**FLOREAT LAKES RESIDENTIAL DEVELOPMENT
NORTH WEST SECTOR HERDSMAN LAKE**

**Report and Recommendations
of the
Environmental Protection Authority**

Environmental Protection Authority
Perth, Western Australia
Bulletin 360 November 1988

Figure 4. Alternatives considered for Main Drains.

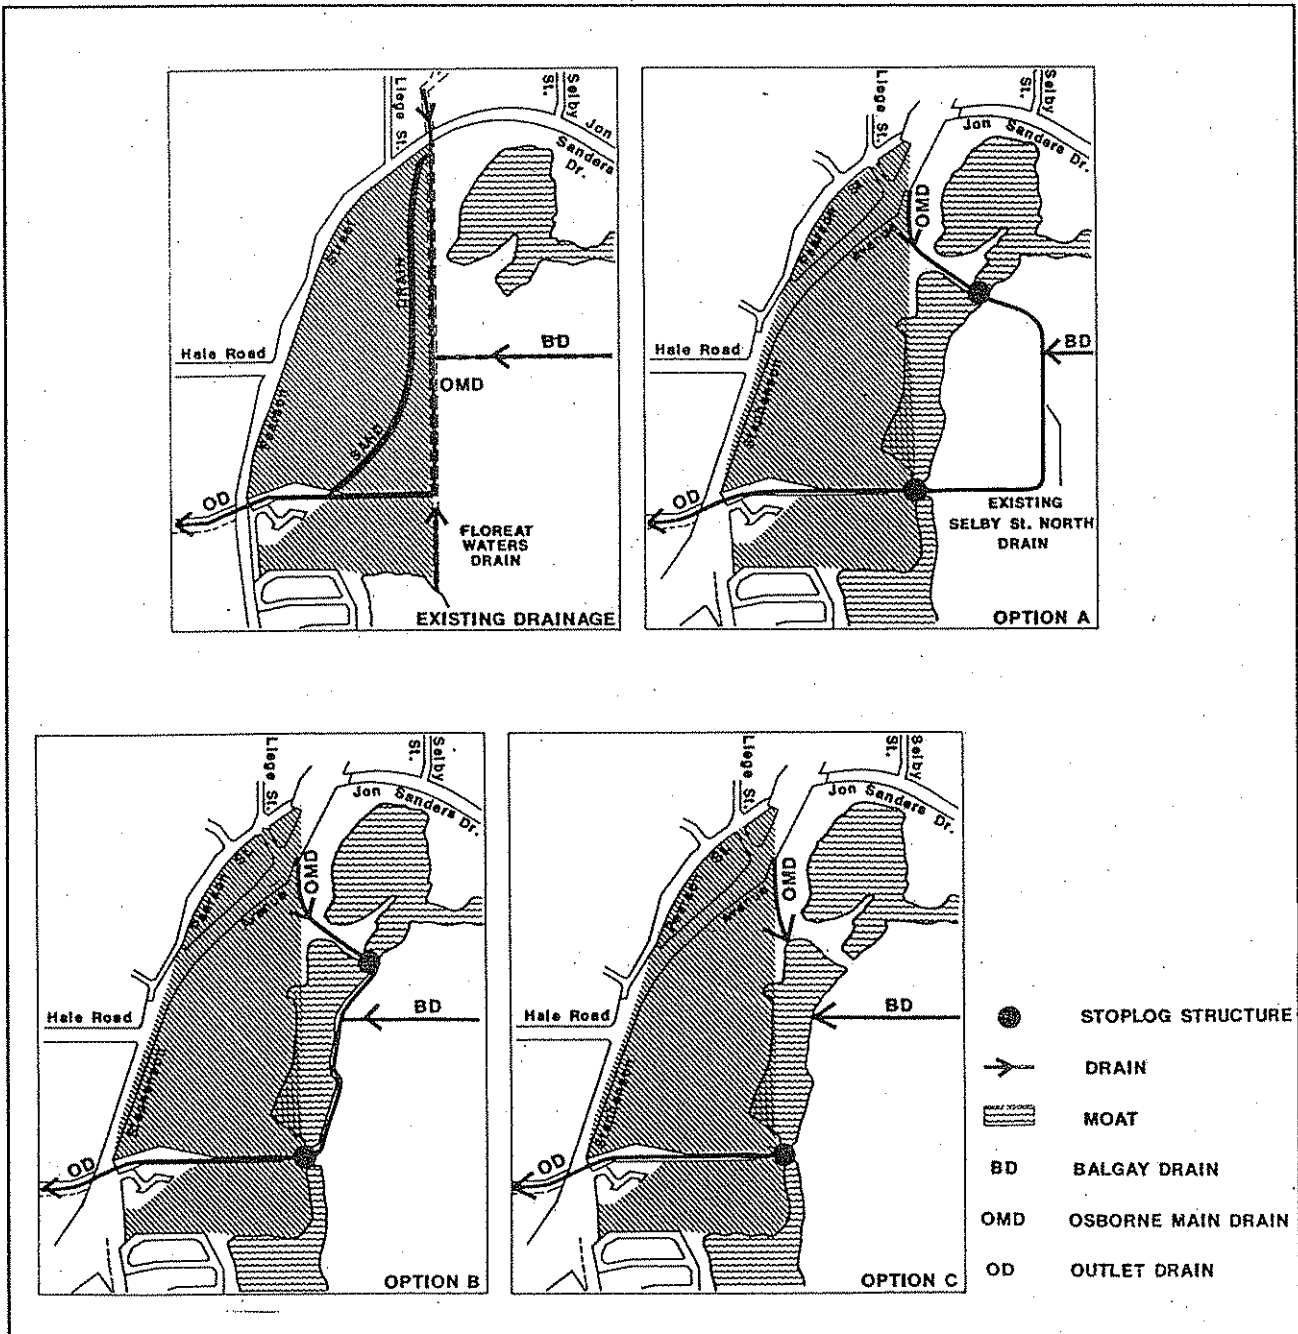
The EPA supports the proposed drainage layout, including the use of stop-log structures to manage the water inputs, presented in the PER providing the realigned Osborne Main Drain does not encroach on the central conservation area (as defined by the "limit of dredging" line in Improvement Plan 21).

Feasible alternatives acceptable to the parties involved (WA of WA, MRD, CALM, SPC, CoS) have been assessed and are shown in Figure 4. The alternatives have been developed to provide the containment and control objectives of the management plan.

Figure C3. Revised figure of Structure Plan.

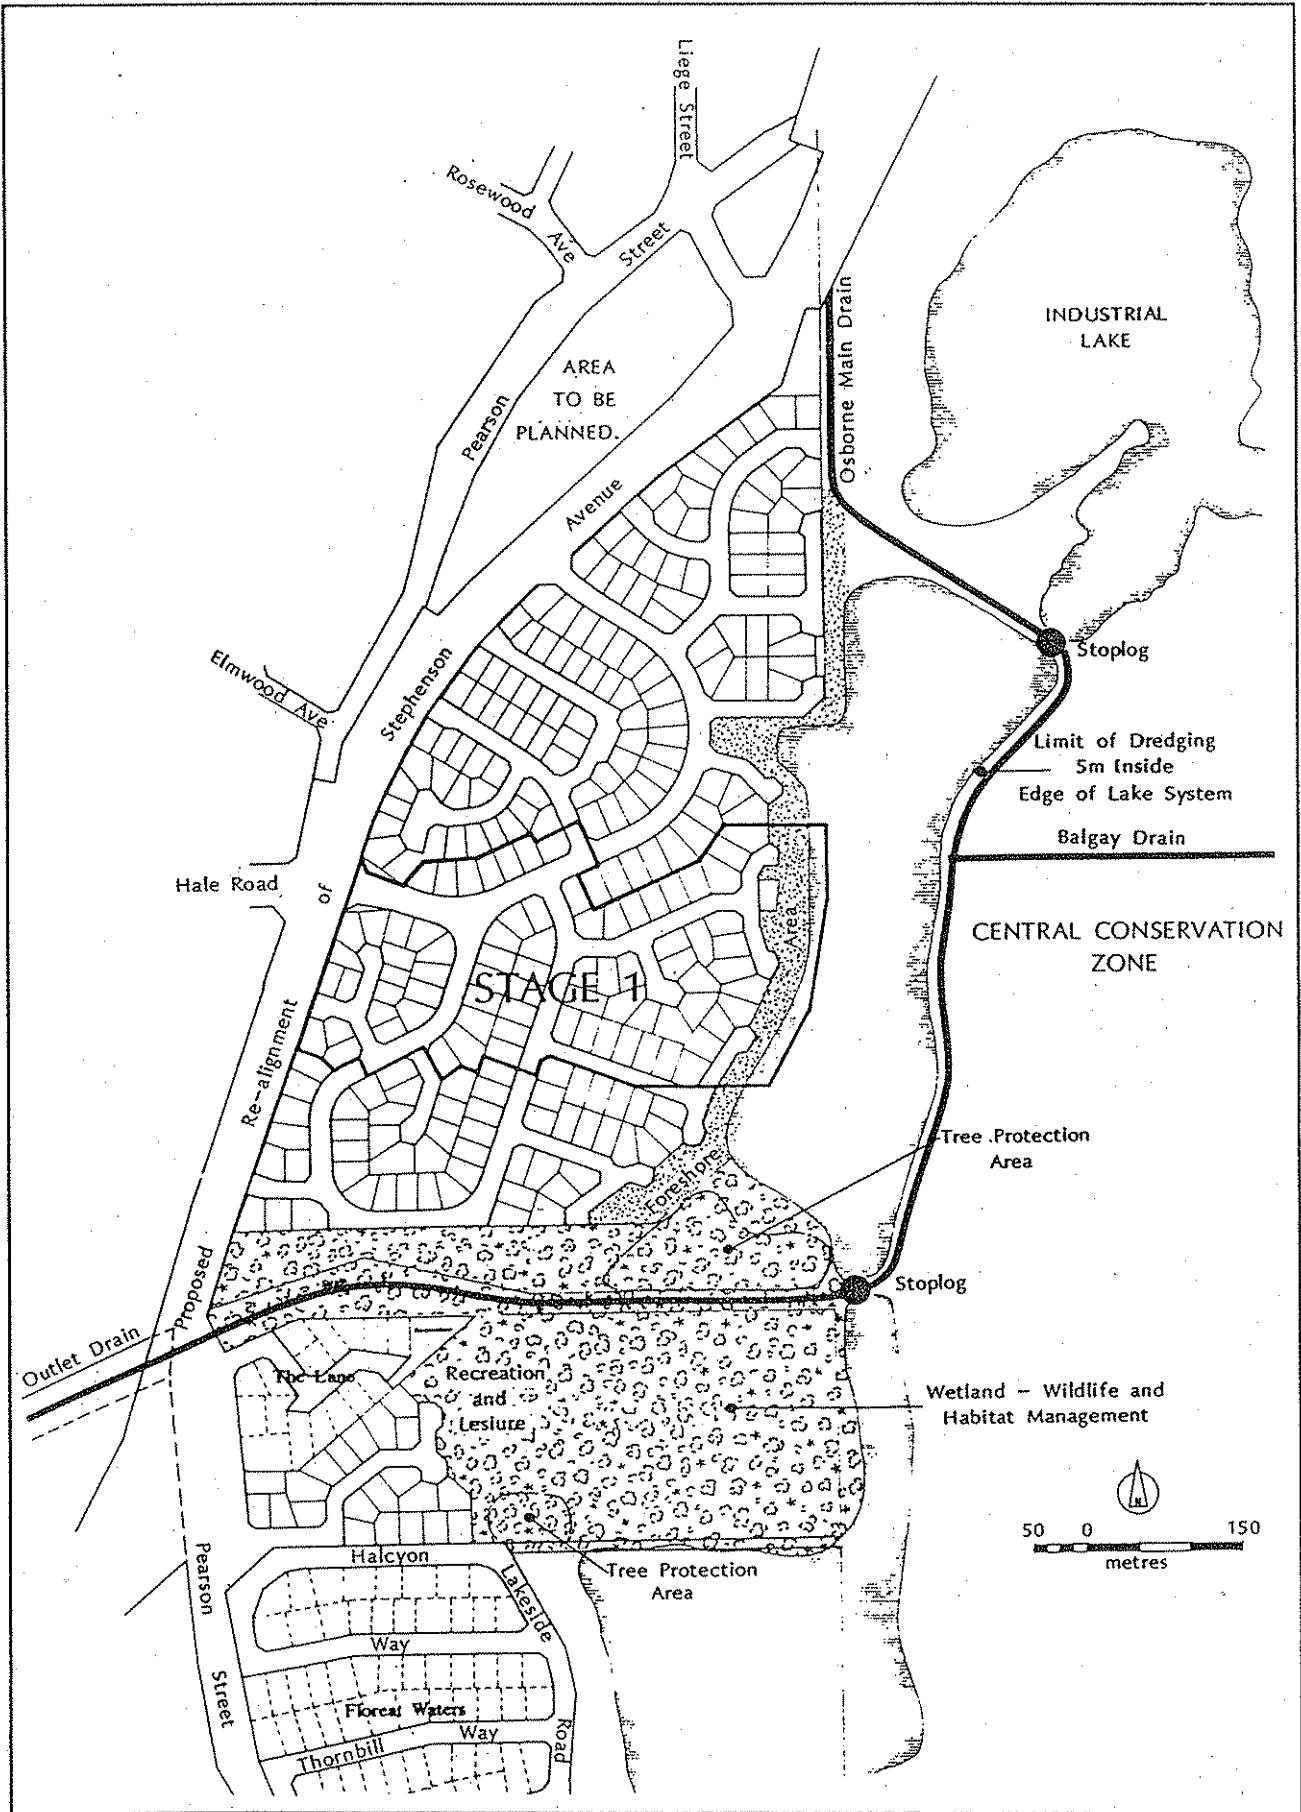
The dimensions of the moat given in the text are different to that indicated in Figure 3 of the PER. How narrow will the moat be between Floreat Lakes and Floreat Waters?

The moat fronting Floreat Lakes varies between 120-200 metres in width. This is consistent with para 5 on page 17. The scale bar on Figure 3 is incorrect. A copy of the revised figure 3 is attached (see figure C3). The moat between Floreat Lakes and Floreat Waters is proposed to be constructed to the minimum width which can be dredged, currently 50 metres. The last 50 metre section near Floreat Waters will be two five metre channels, creating an island. Discussion on this design is continuing.
